The Great Grid Upgrade

Norwich to Tilbury

2023 Non-Statutory Consultation Feedback Report

AENC-NG-CNS-REP-0007

Figure 4.24- Thurrock section map

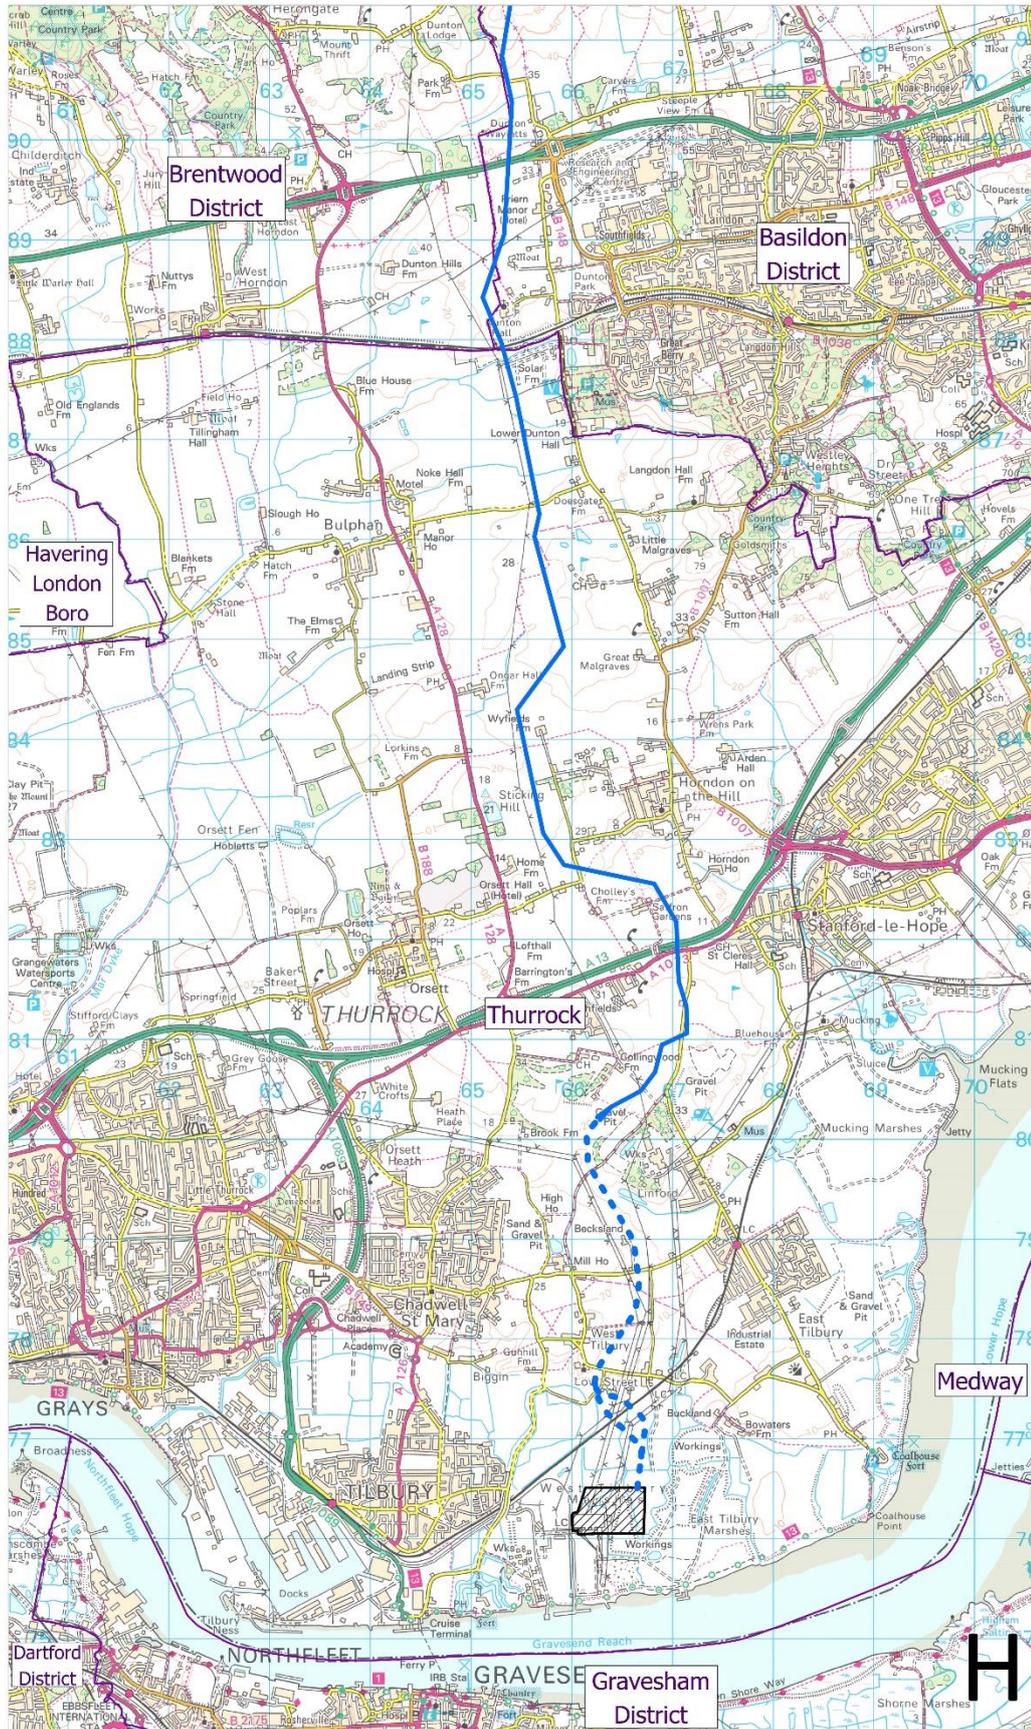
Ref no.	Summary of matters raised	National Grid's response
Agricultural Land		
4.17.1	Concern that the Project will take away valuable agricultural land / disrupt farming operations.	National Grid is and will continue to work with all landowners including farmers who may be affected by the proposals to understand the impacts on their operations and to work with them as the Project is developed. We will seek to work with the farming community to limit disruption where practicable. This includes providing prior warning of works which may result in the need to move livestock. Compensation claims for disturbance are considered on a case-by-case basis, if negative impact on farming operations can be proven. Particular agricultural matters can also be addressed through voluntary land agreements.
